IN THE MATTER OF LAHONTAN
REGIONAL WATER QUALITY CONTROL
BOARD RESOLUTION NO. R6V-2013-0060
CERTIFYING A FINAL ENVIRONMENTAL
IMPACT REPORT

CASE NO.
PETITION FOR REVIEW
REQUEST TO HOLD PETITION IN
ABEYANCE

**Attachment 1 –Main Comment Table
Hinkley Comprehensive Groundwater Cleanup Strategy
Draft Environmental Impact Report**

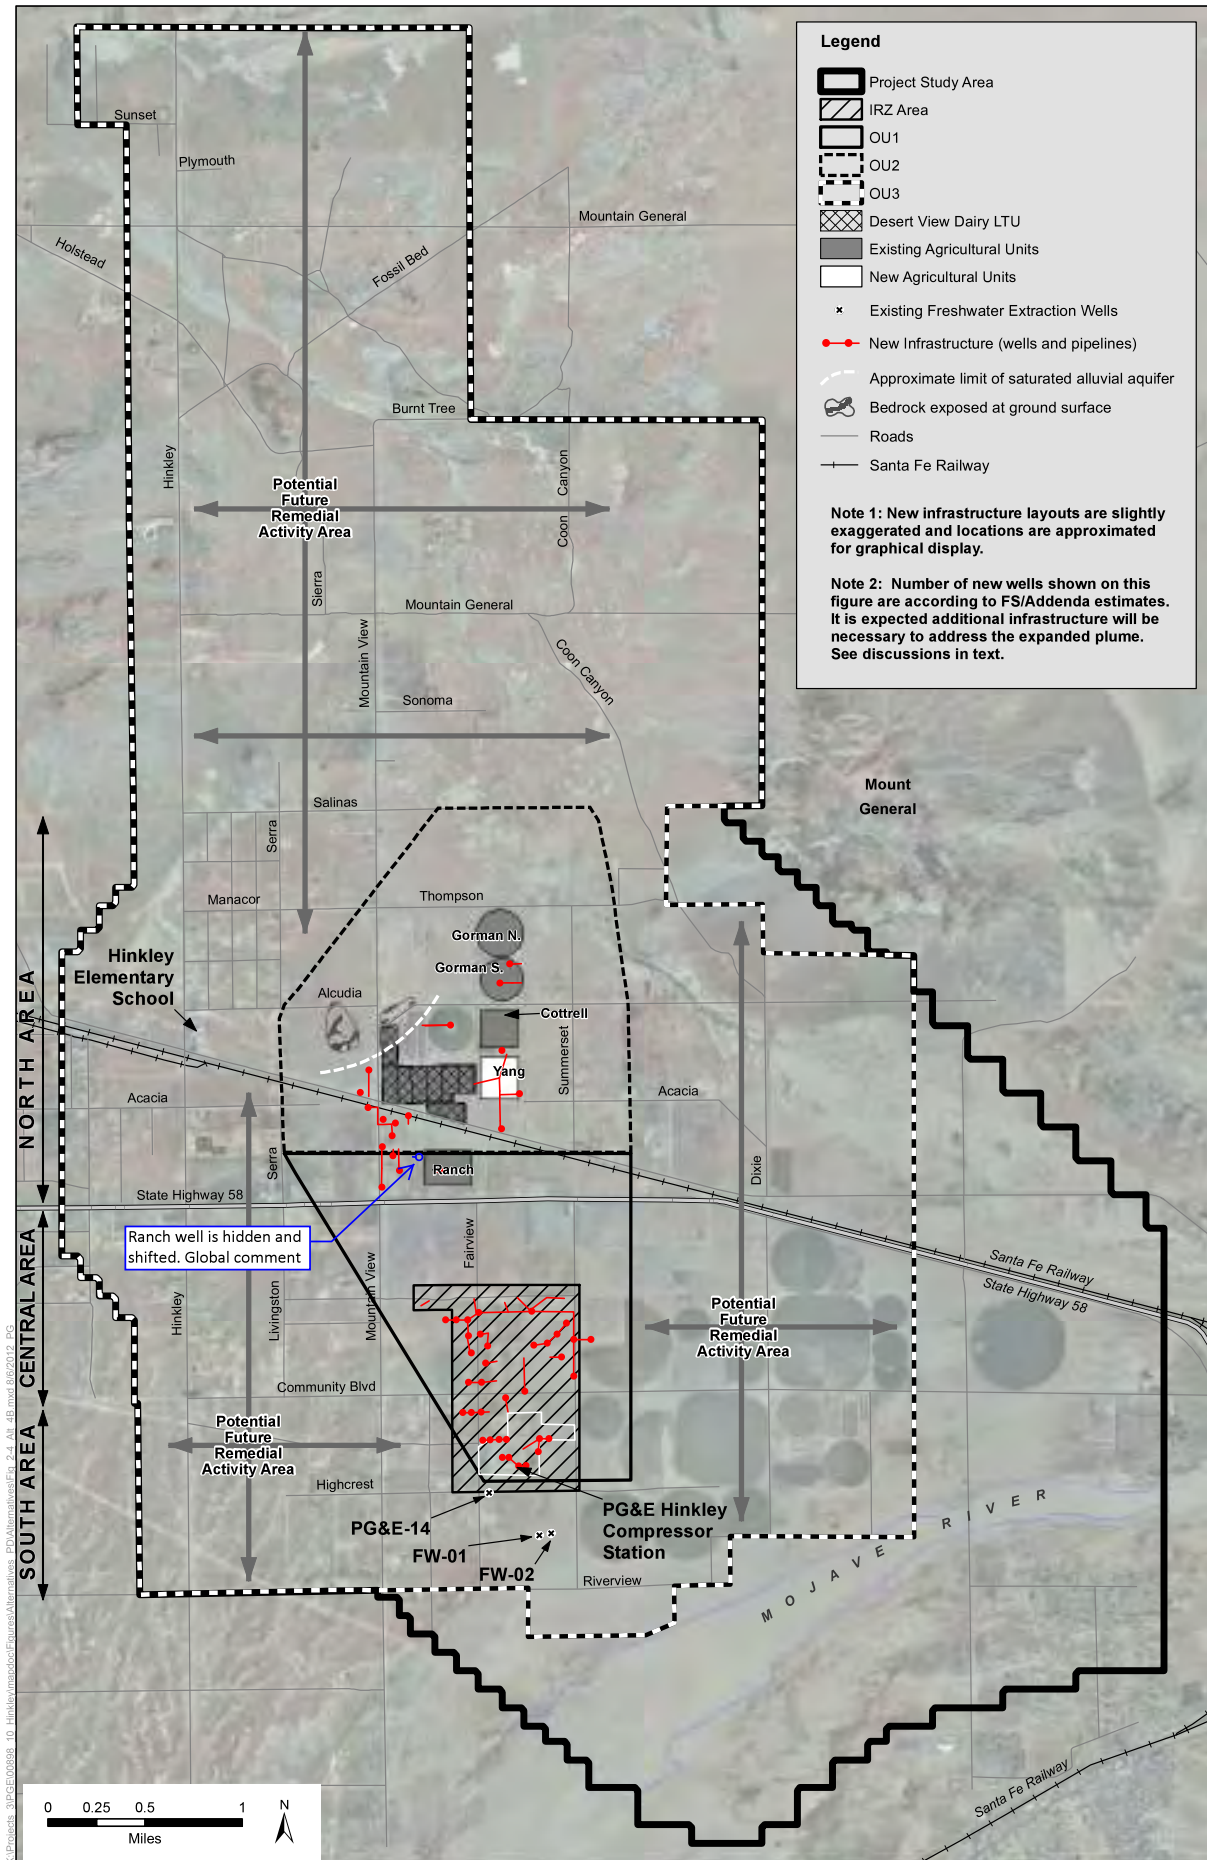
gpm = gallons per minute

Comment [d1]: Totals are linear feet of trenching, we suggest adding a note to clarify

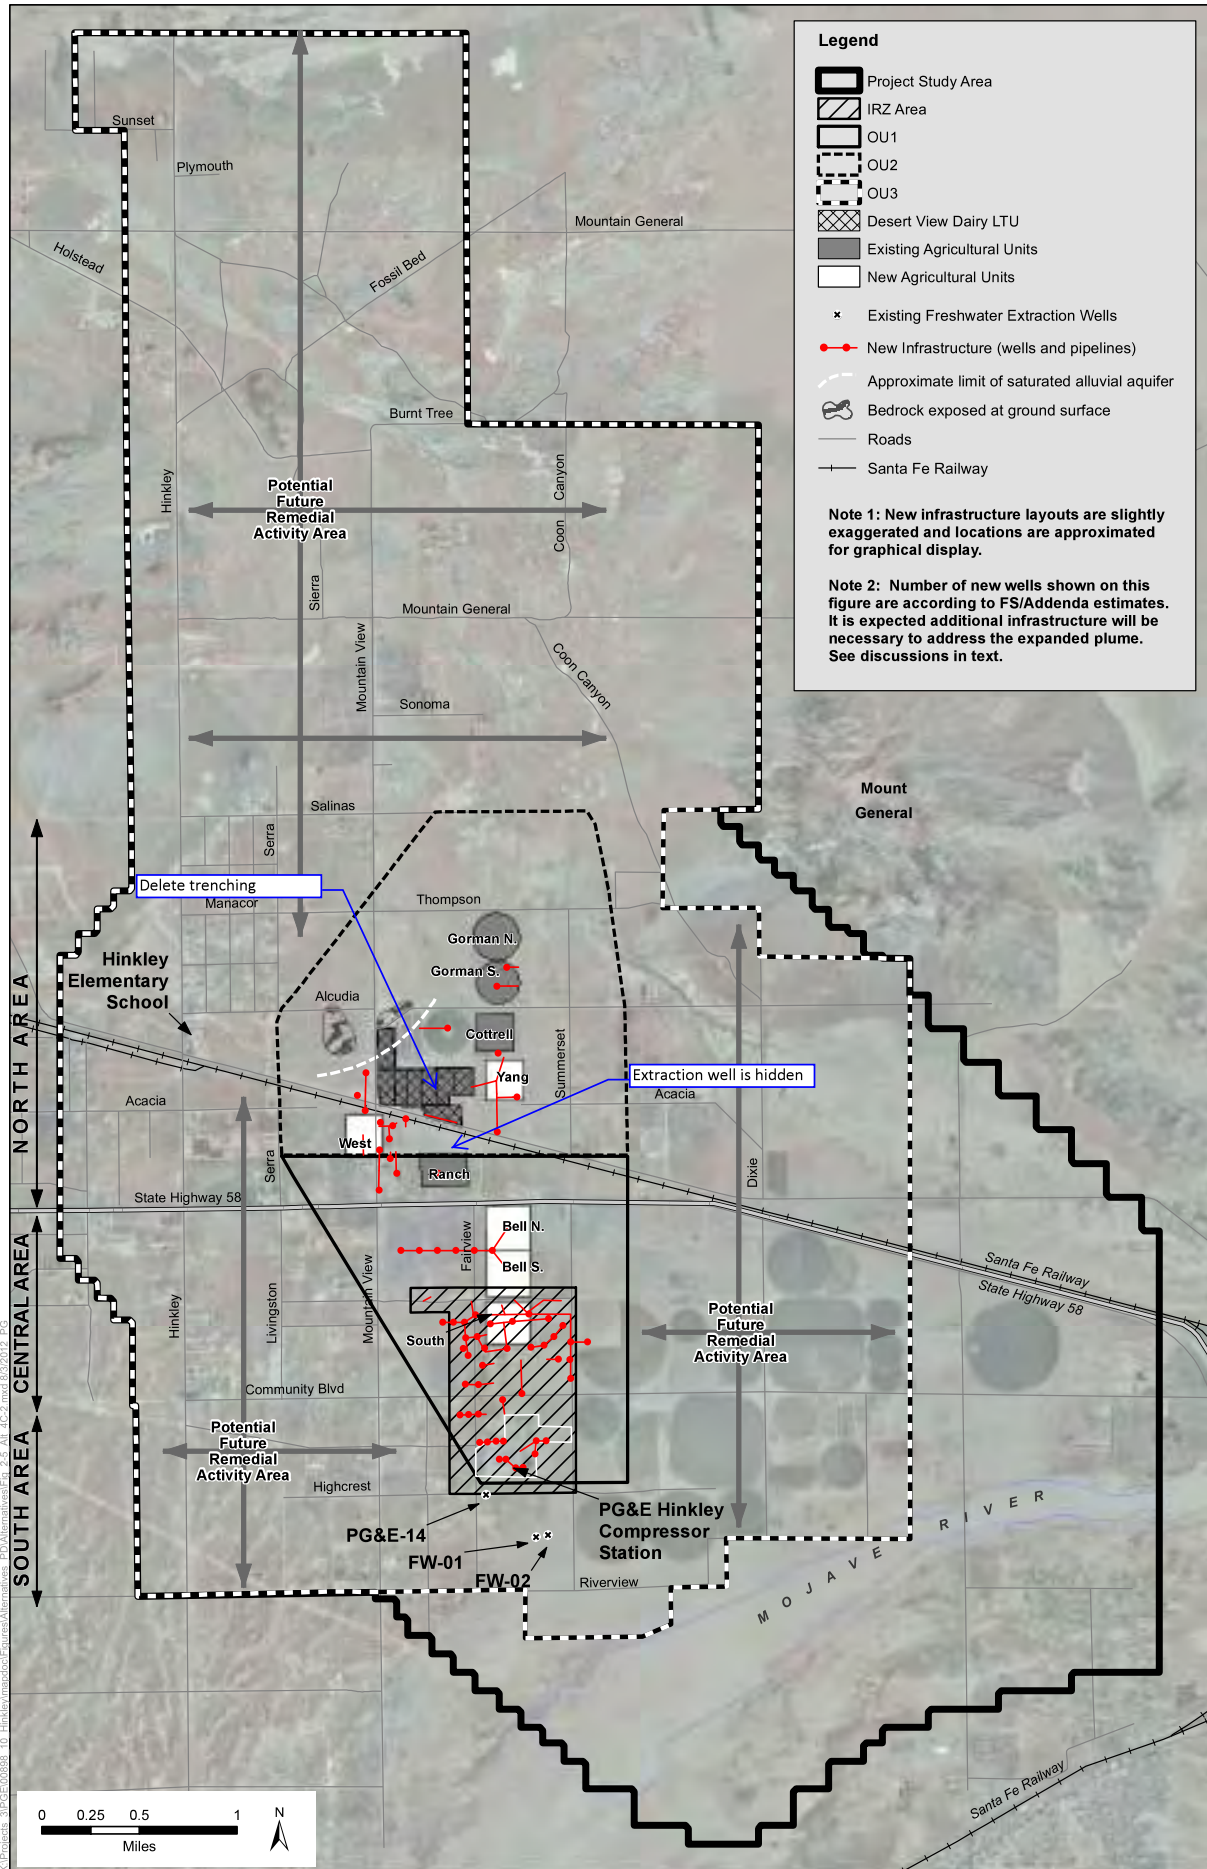
Comment [d3]: 5 + 15% contingency

Comment [d4]: Suggest clarifying that well estimates include the number of wells to be constructed; not all wells may be operating at one time

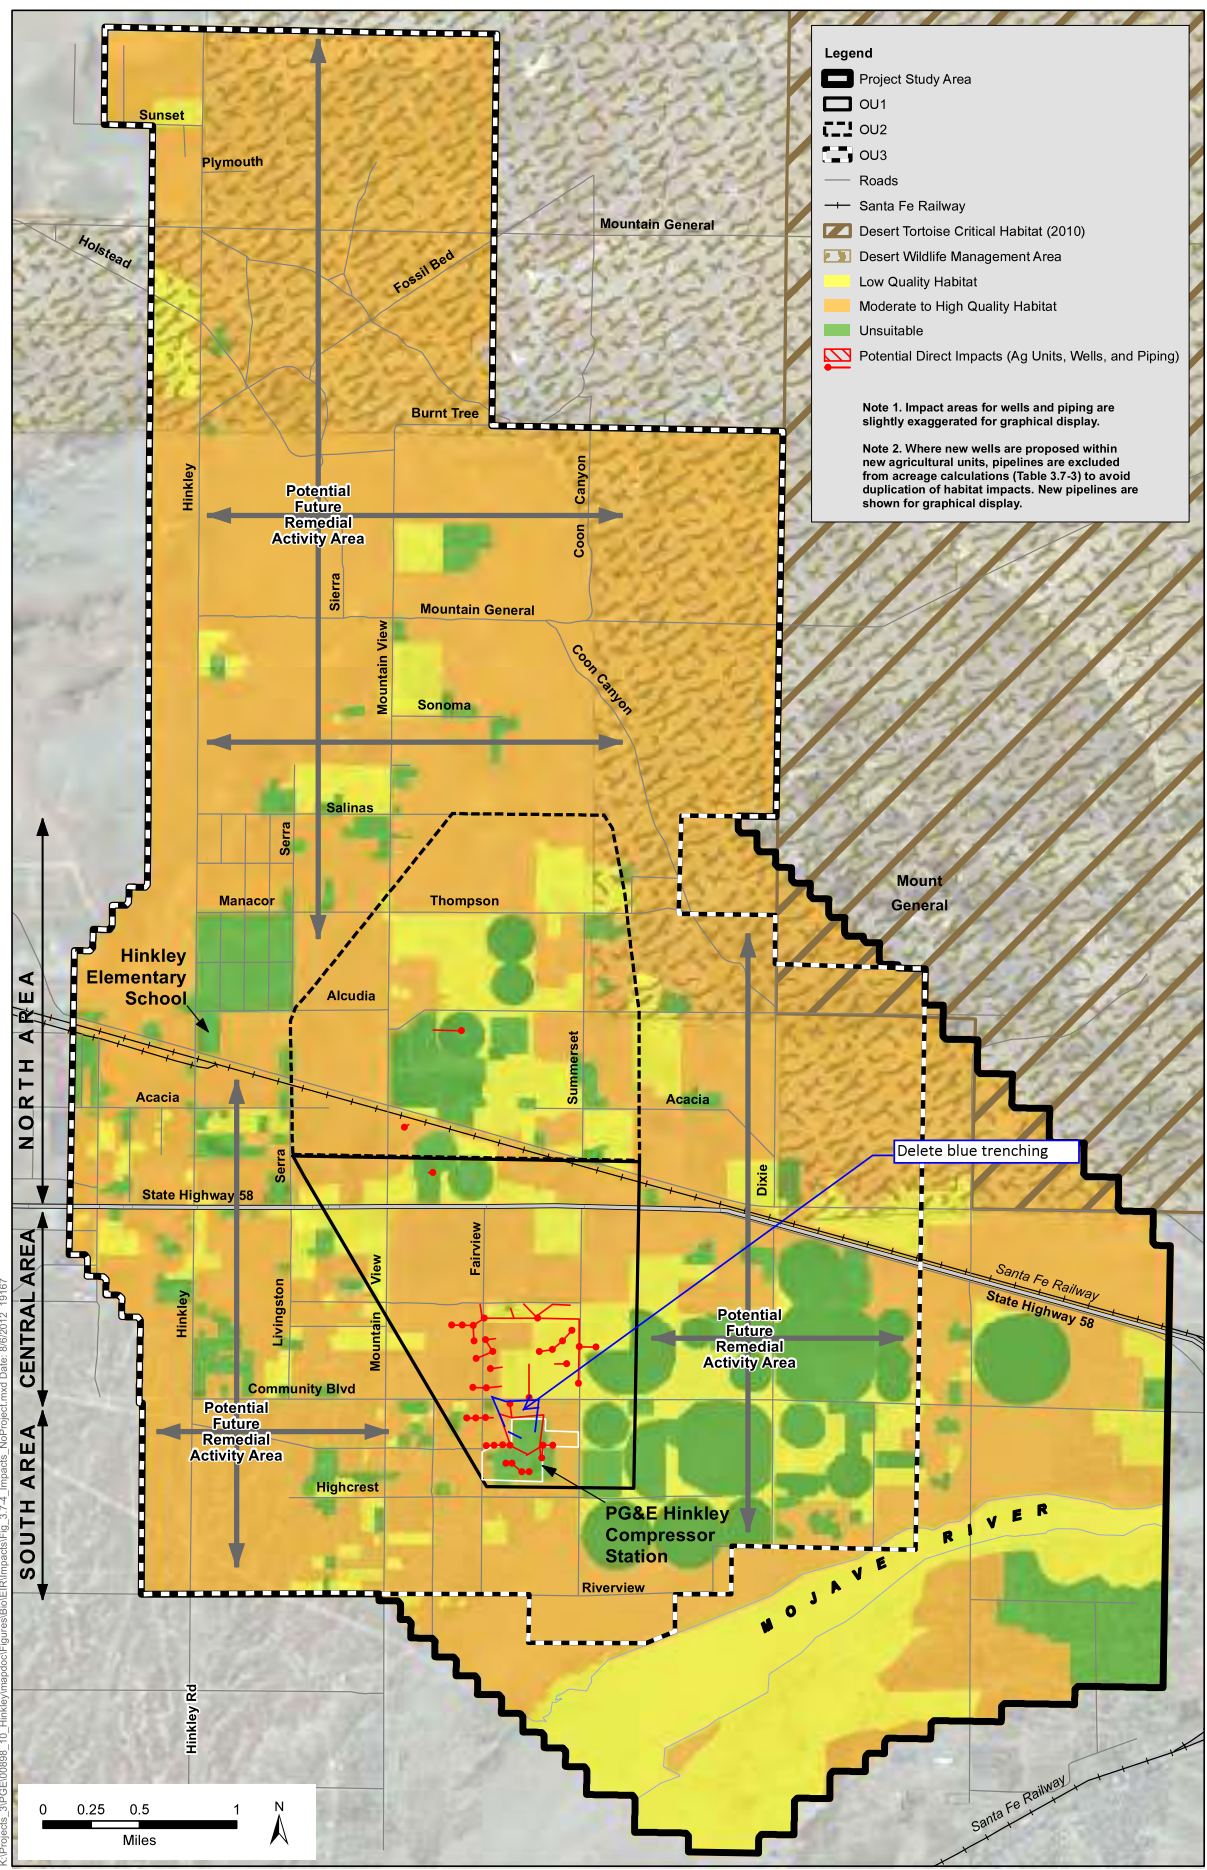
Comment [d11]: 240 VMT /month not daily

Comment [d12]: 424 VMT /month, not daily
